ADDENDUM
NO. 2

October 31, 2023

HANOVER COMMUNITY SCHOOLS - JANE BALL ELEMENTARY RENOVATIONS AND HIGH SCHOOL IMPROVEMENTS

SHEET M-103

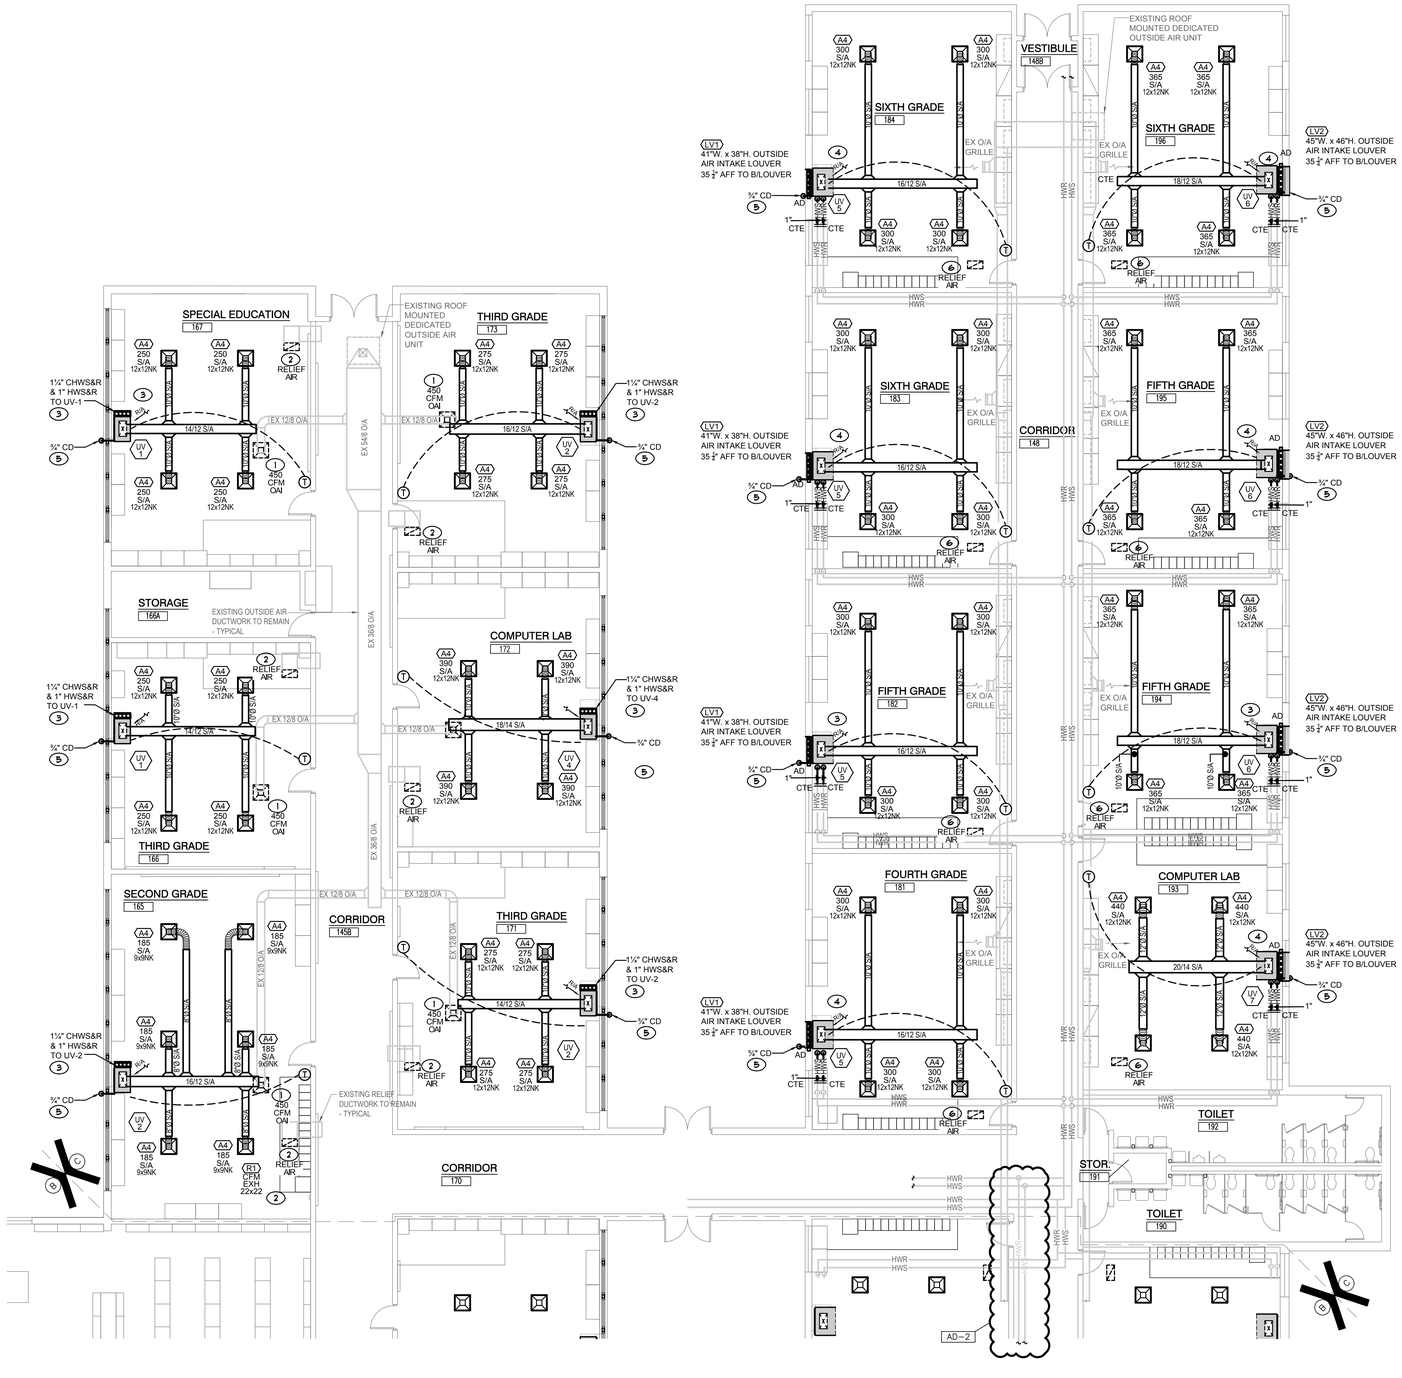
A. Add existing piping.

UNIT "B" FIRST FLOOR DEMOLITION PLAN - ELECTRICAL

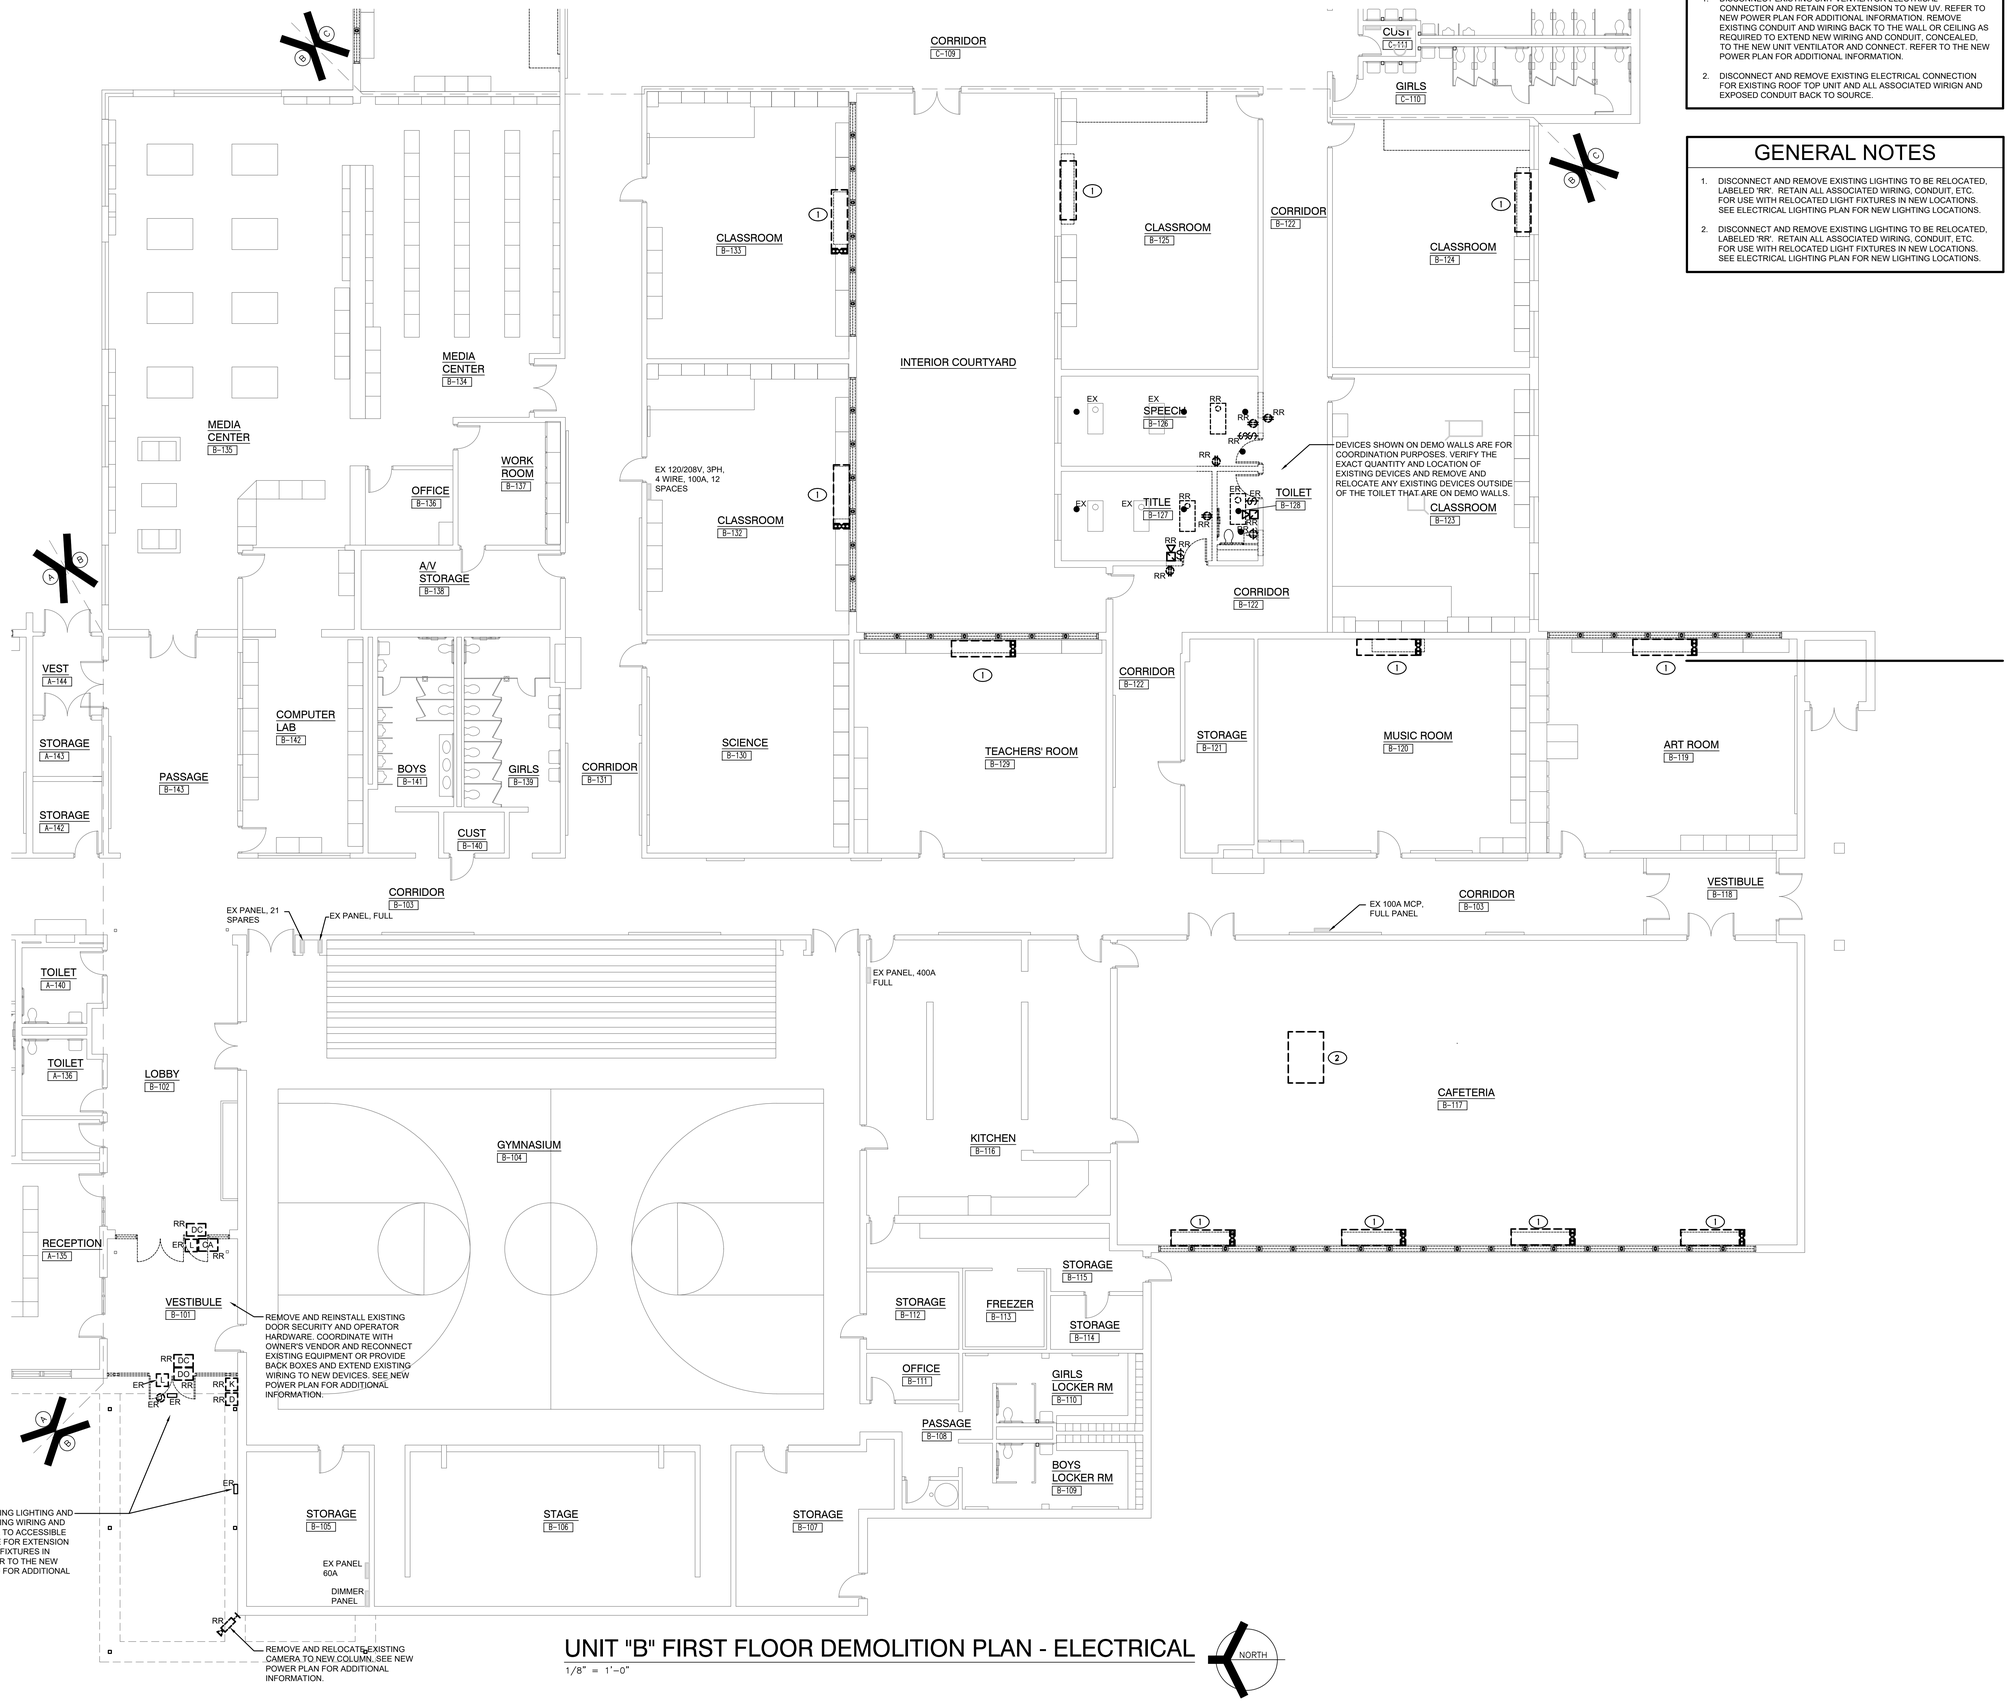
A. Revised demolition wall requirements. Refer to revised drawing for additional information.

SHEET E-202

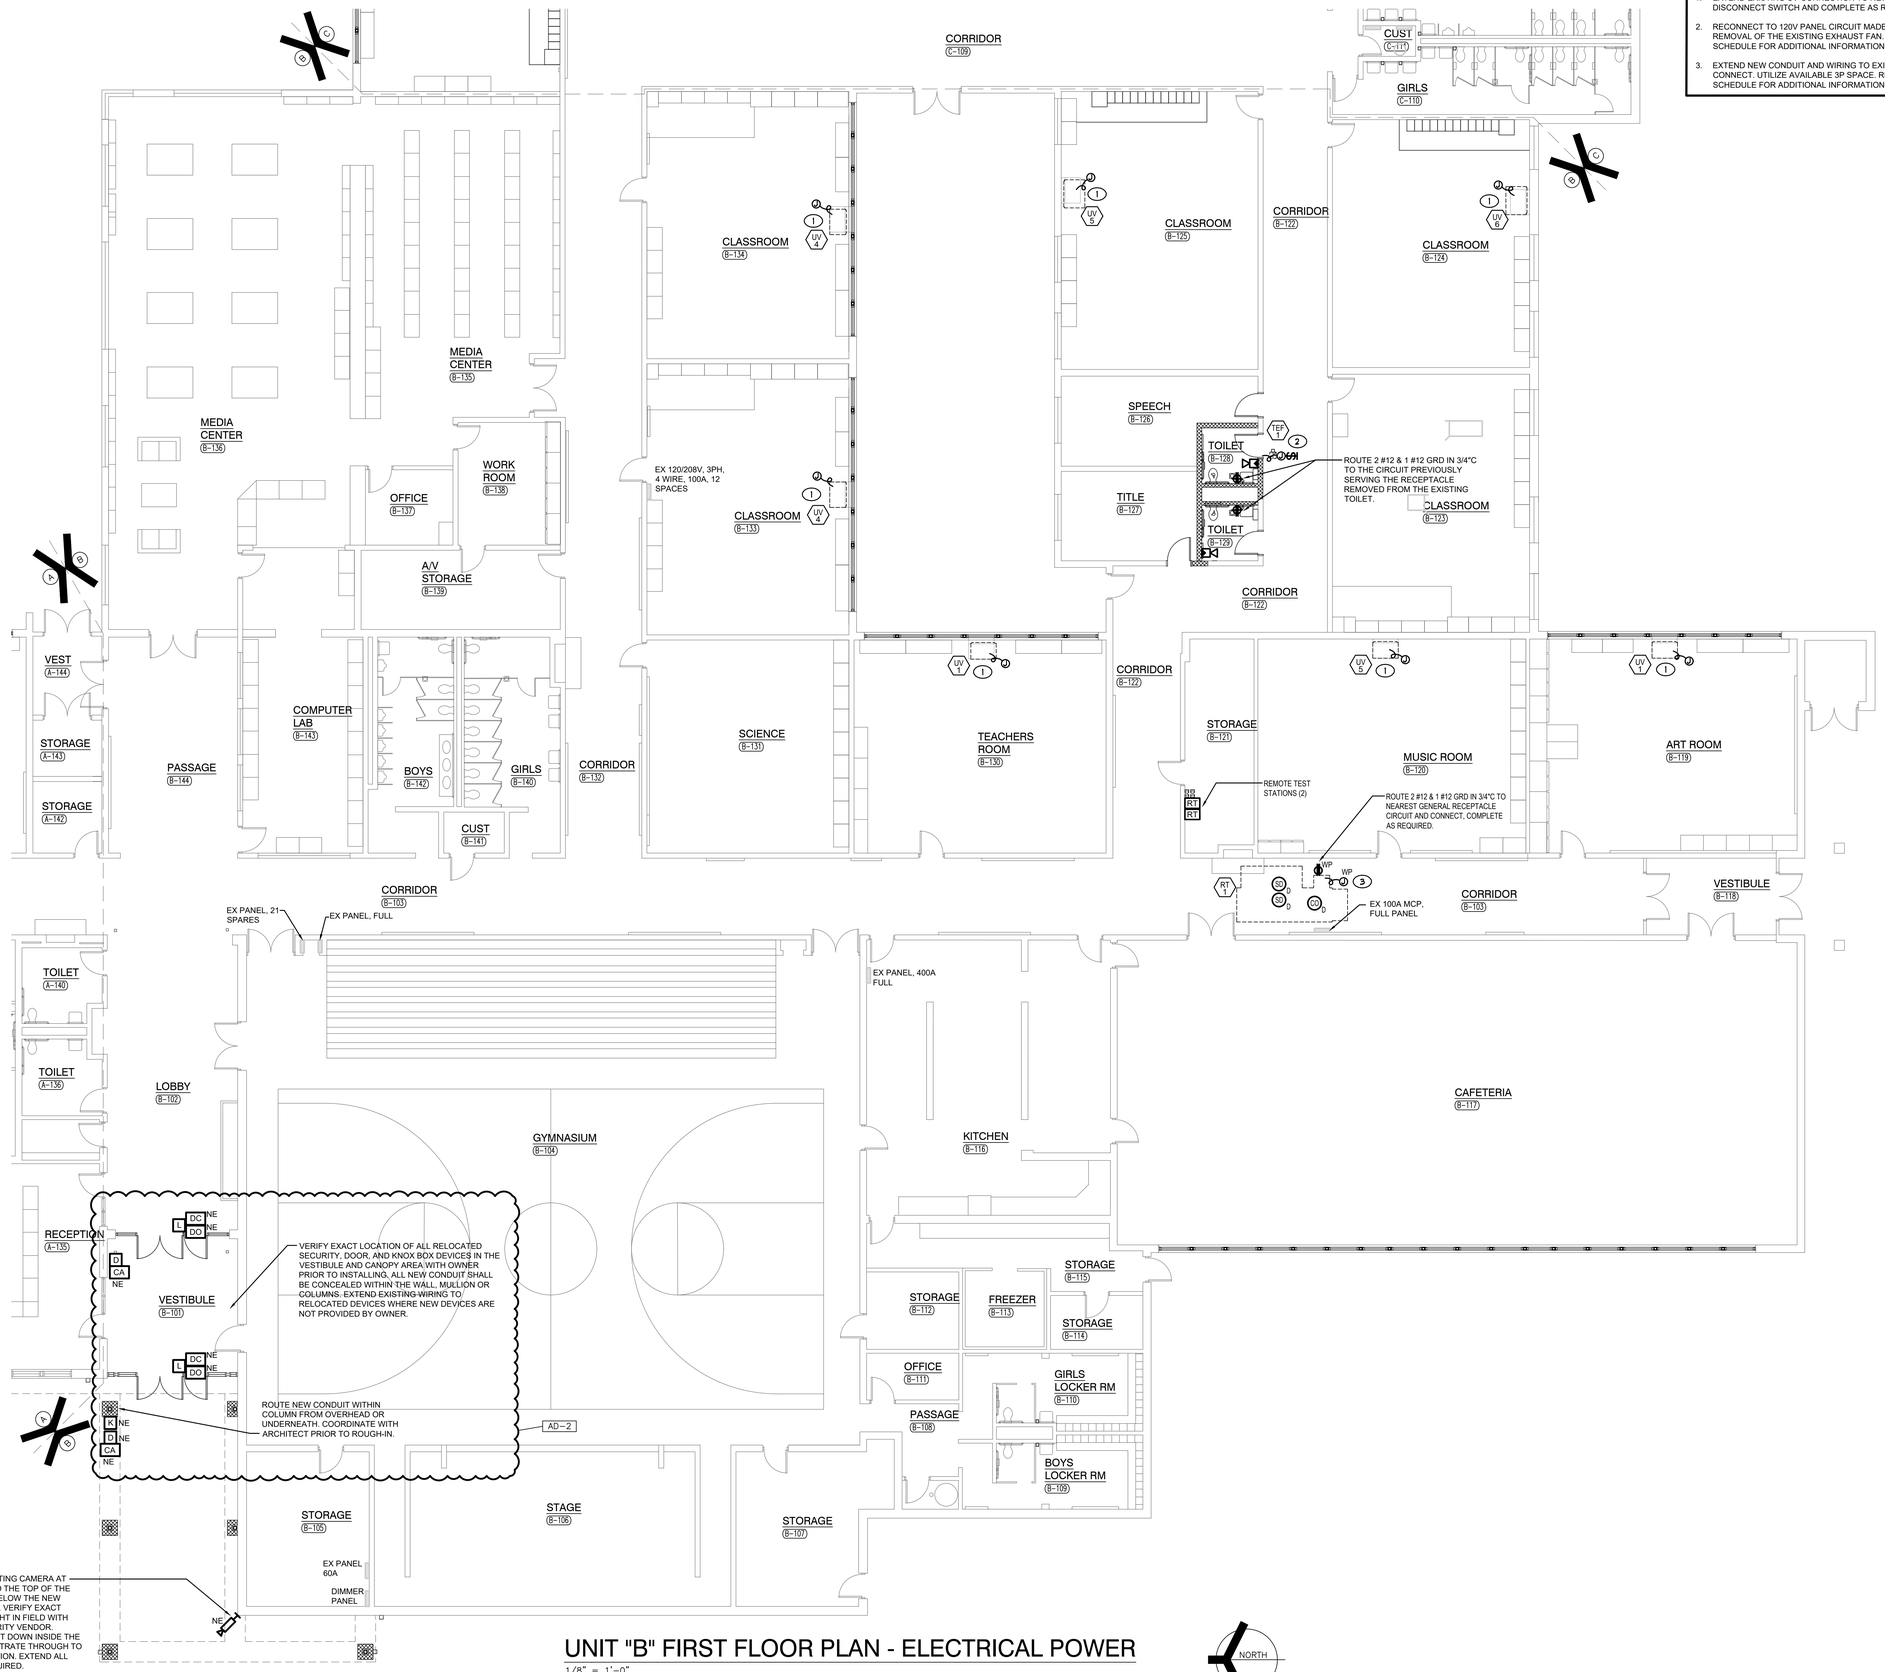
A. Revised electrical power and low voltage device requirements. Refer to revised drawing for additional information.
